Memorandum

Re: Final Minutes of the September 21, 2022, HCP Hatchery Committees and PRCC Hatchery Subcommittee Meetings

YN Responses to HCP-HC and PRCC HSC Questions on the Spring Chinook Salmon Acclimation at Goat Wall

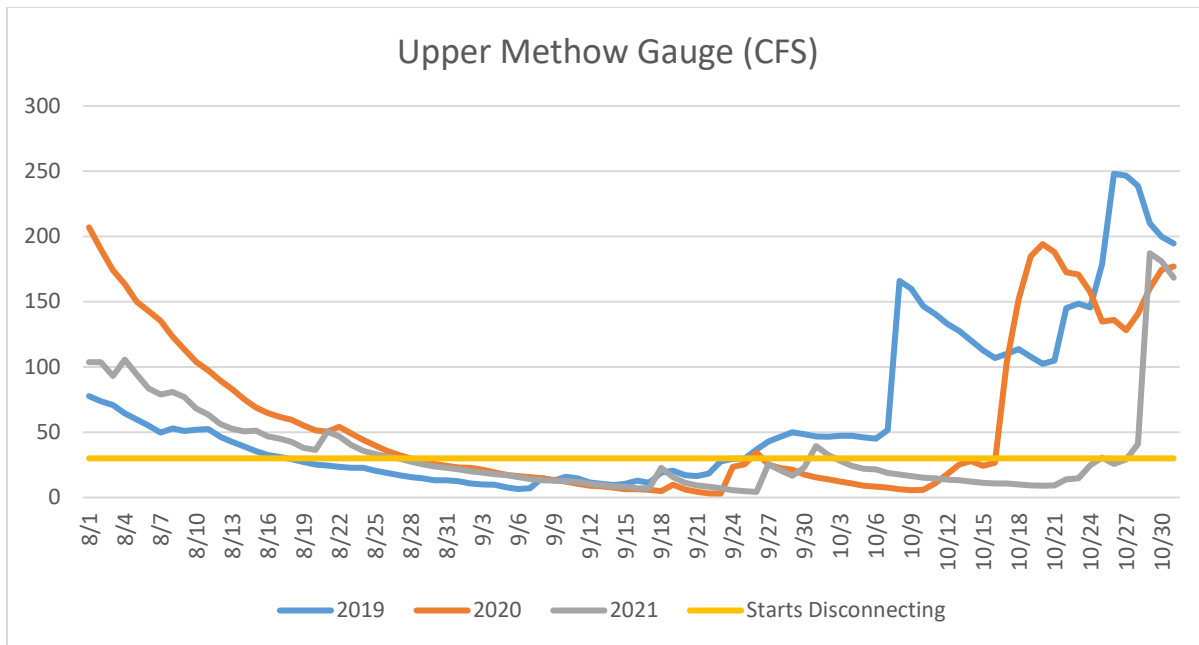
- 1) What % of redds created by adults that were acclimated as juveniles at Goat Wall Acclimation Facility would be predicted to produce no progeny based upon redds going dry prior to juvenile emergence from redds? Please provide annual estimates.**

An estimate could be made by looking at the historical relationship between stream discharge and the time of stream reach drying after spawning. Data should be available for the past few decades, but some assumptions may be required to produce estimates.

In the upper Methow River there are two sections with spawning gravel that go dry; the lower half of M14 to the bottom of M13, and around the confluence of Goat Creek which is in M11 (this is near the Upper Methow Gauge). M14 does have some good spawning gravel in the drying section and M13's more recent redds are in the upper section. I have two Google Earth images below that help explain where these reaches are in the basin. The first image is of M13/M14 below the Lost River and the second image is of the M11 reach.

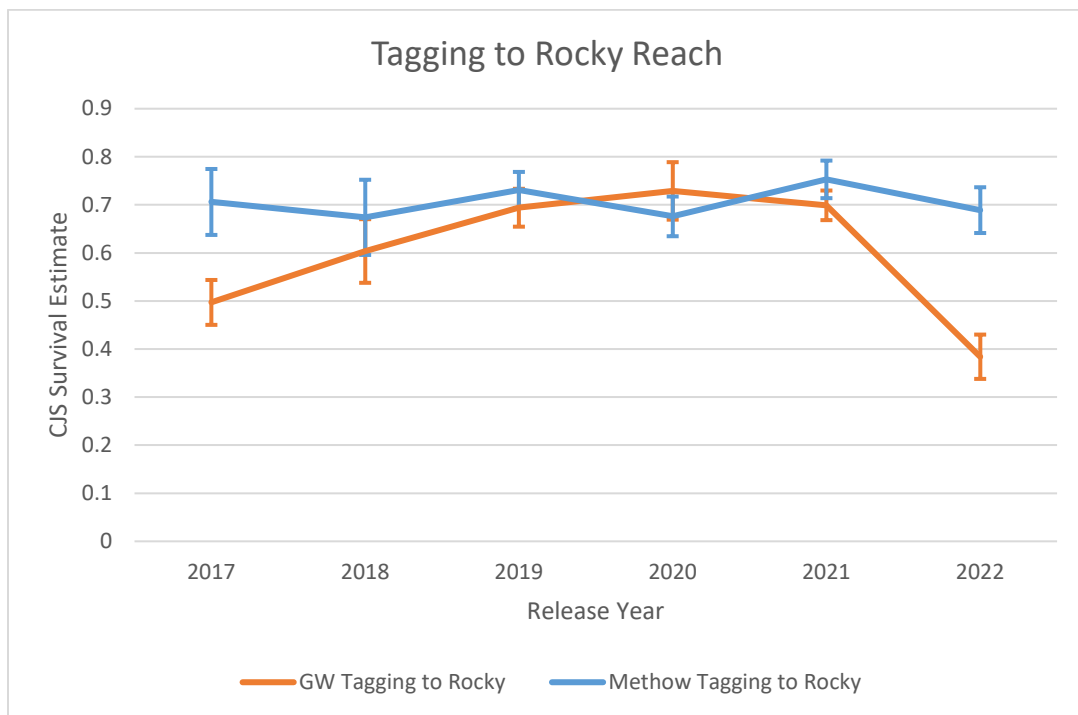
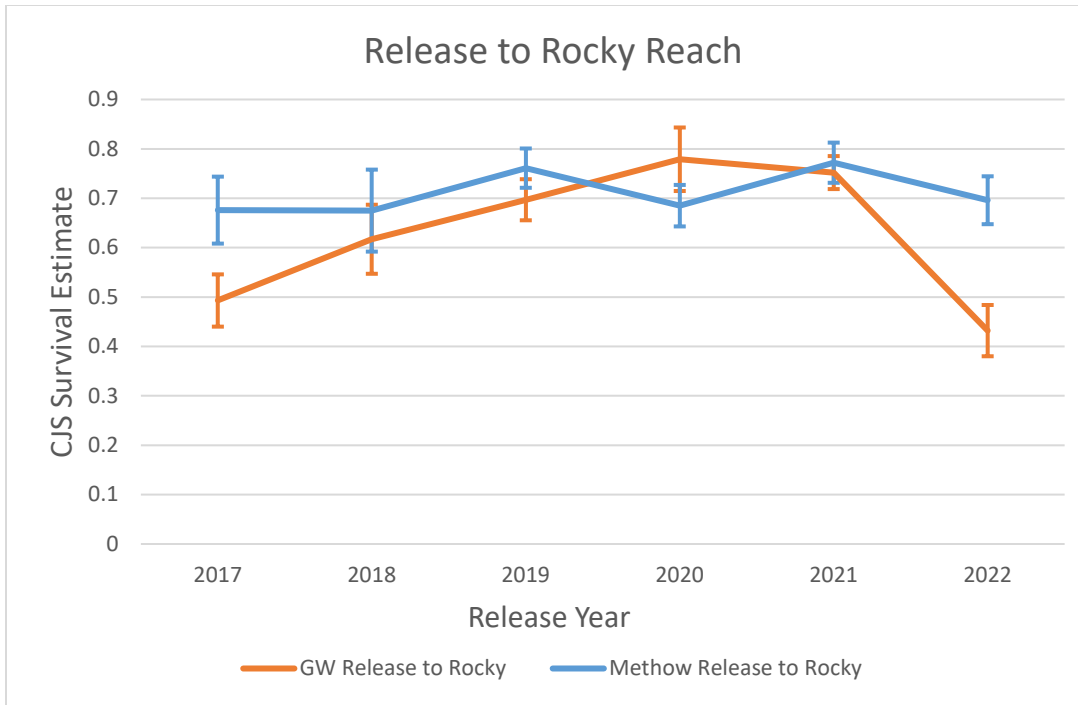
1) Slide #6 depicts the spring Chinook carcass recoveries in the Methow River (presumed spawning location) based on a geographic description of low, middle and upper Methow River. Is it possible to provide the same information, but include the rkm rather than the general low, middle and upper classifications? What I'm concerned with, is the proximity of recovered carcasses to the dewatered reaches in the Methow River. It appears as if the Goat Wall fish do not spawn in the "lower" areas of spring Chinook habitat and occupy the middle and upper reaches, which at first thought seems like a good thing. However, if they are occupying habitat in the areas prone to dewatering during the spawning/incubation/early rearing periods then that could be detrimental. It appears as if the natural origin fish occupy predominantly the "middle" reaches (~67% of the carcass recoveries) and less so in the "upper" reaches (~ 30%). Conversely the Goat Wall carcass recoveries indicated the majority of the recoveries (~60%) were recovered in the "upper" reaches. Proportionally, the Goat Wall fish appear to be occupying the "upper" reaches in much higher proportion than the natural origin fish. Why might this be? longer-term habitat conditions limiting natural production in the "upper" reaches? I don't know, but if this were to be the case, an artificial propagation program that returns the majority (~60%) of the returning hatchery adults to a geographic area with limited productivity potential may be detrimental to overall spring Chinook production in the Methow River.

Here is a graph of carcasses (both male and female) for NOR, on-site releases (MC-Met), and Goat Wall acclimated fish (MC-GW) at each RKM for all years combined. I have included the location of Methow Hatchery and Goat Wall Pond. The two drying areas are referenced as well; around Goat Creek (which can be up to 2 RKM) and M13/M14 which is shown as the "Drying Area". A couple things to note. This is just carcasses and not an expansion of escapement. This means that a single carcass can expand to more

than one fish depending on the year and reach. Also, I did not include Early Winters carcasses in this graph because then they would be included in the drying area. Early Winters would add two NOR carcasses and one more Goat Wall carcass.

Goat Wall fish are found amongst NORs in the majority of the upper RKMs, within the drying areas, and above and below the drying areas. In fact, acclimation clearly extends spawning of conservation fish to the upper reaches of the Methow River helping to supplement those areas. It is important to remember that this expansion is balanced out by the Methow on-site releases. Goat Wall fish are the same stock/genetics/fish as Methow FH. So when you combine the escapement of both releases, we see that returns cover the basin as a whole and in a manner similar to NORs. This result likely gives this population a better chance to persevere by spreading out risk during these early life stages.

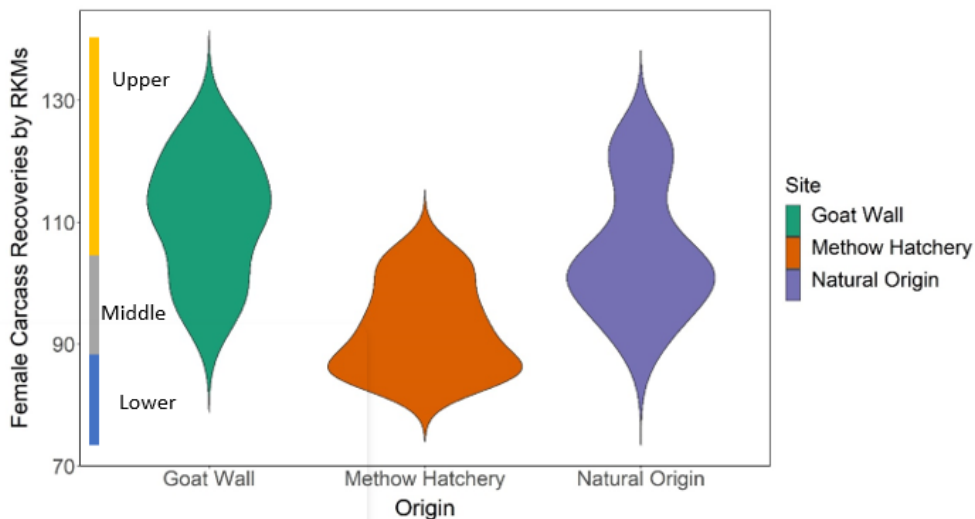
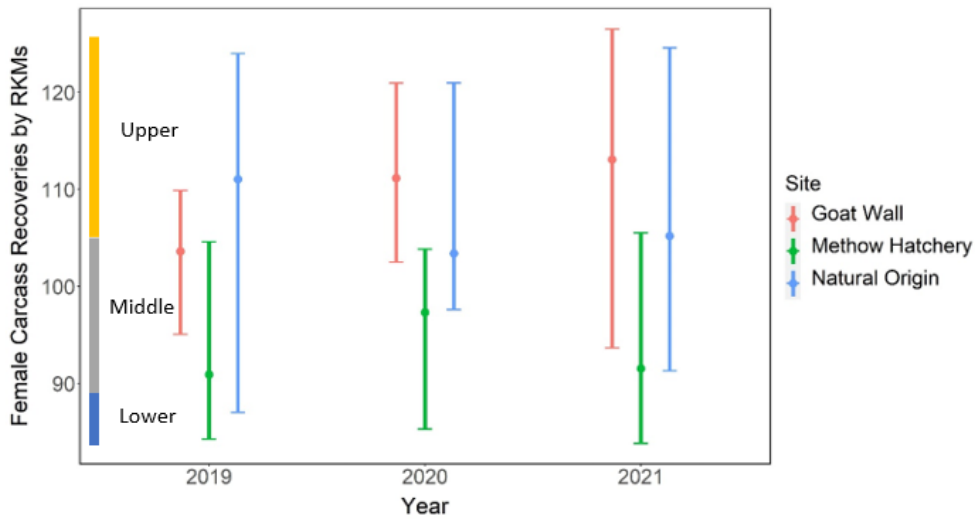
1) *The proposal demonstrates that Goat Wall acclimated spring Chinook mirror the natural-origin population's spawning distribution thus increasing spawning in the upper and middle Methow River while also having low rates of hatchery removal. We are concerned that an expansion will likely decrease the ability of the Service to reach its pHOBC goals (>75%) for WNFH's Safety-net program. This year will be the first time since 2016 that WNFH will make its pHOBC goals. It seems we can only reach the pHOBC goals only in very good return years just based off Methow Hatchery returns alone. Will having a small increase in the number of fish in the upper reaches outweigh the impacts of having a more domesticated Safety-net stock at Winthrop NFH during low return years? In high return years, how do we effectively manage pHOS in the middle and upper reaches, when we cannot remove Goat Wall / Early Winters fish?*

To be clear, right now we are focused on the *continuation* of the program at the current release numbers. This would not result in a change of pHOBC for Winthrop. For now, we would like to wait for 5 years of adult data to be completed to better inform on the expansion potential. At that point, expansion would be another decision for the committee to make based on results from a complete data set. We included the possibility of expansion in previous discussions so that the HC would know what direction we ultimately would like to take the program.

One of the main goals of the program is to determine what release size is necessary to increase distribution to enhance the supplementation effort while staying within bounds of pHOS/PNI goals. We need additional data to better inform us on these points. Considering this is looking like a high escapement year, we might have better data even after this year. Also, my understanding is that pHOS is managed at a basin wide level, not at the reach scale..?

Flow at Upper Methow Site
2007 - 2021

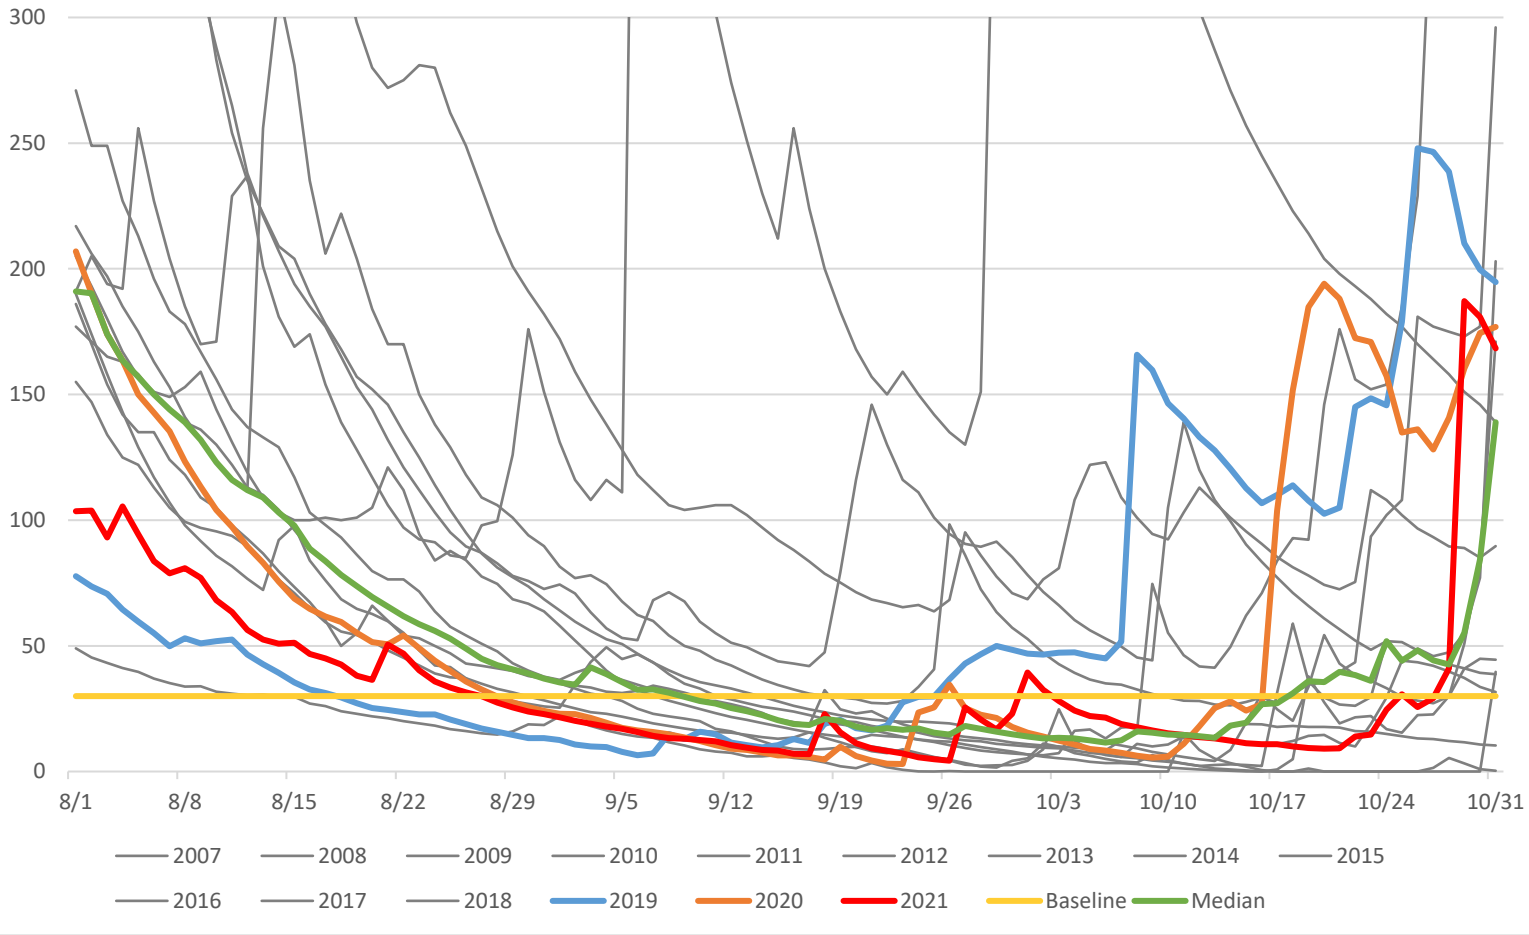
Tracy Hillman asked if adding additional years of stream flow data to the Upper Methow Gauge graph would help Pearsons in his interpretation. Pearsons said it may, and it may also open more questions if the hydrograph tends to fall below the yellow line in all years (the yellow line shows when the river starts to become disconnected). Hillman said it could help answer the question of whether the past 3 years are typical. Pearsons agreed. Rod O'Connor said based on a quick look at the U.S. Geological Survey gauge data, there is a huge amount of variability in stream flows in that area. *(Note: Grundy followed up by email on September 26, 2022, with a plot of the hydrograph at the Upper Methow gauge with additional years of data dating back to 2007 [Attachment C]).*

Murdoch said she can talk to Grundy about including additional individual years of stream flow data to show the variability. Hillman suggested showing all past years as one color to differentiate them from the past 3 study years and Pearsons suggested that an alternative approach is to add another graph showing the previous years.

I graphed out both the flow and gauge height of the Upper Methow gauge from 2007 thru 2021. I added the gauge height since that is likely more appropriate with longer data sets. The gauge value is about 13 when disconnection begins in the upper Methow.

I left 2007 thru 2018 as gray lines while defining 2019-2021 with different colors. The yellow line depicts about when the river begins to disconnect and travels underground. I also added the median values as a green line. The medians were generated from all the years that are graphed (2007-2021). The median suggests that the timing of drying is generally the end of August/early September and fall freshets are generally occurring by the end of October. Year 2020 and 2021 seem to track fairly well with the median.
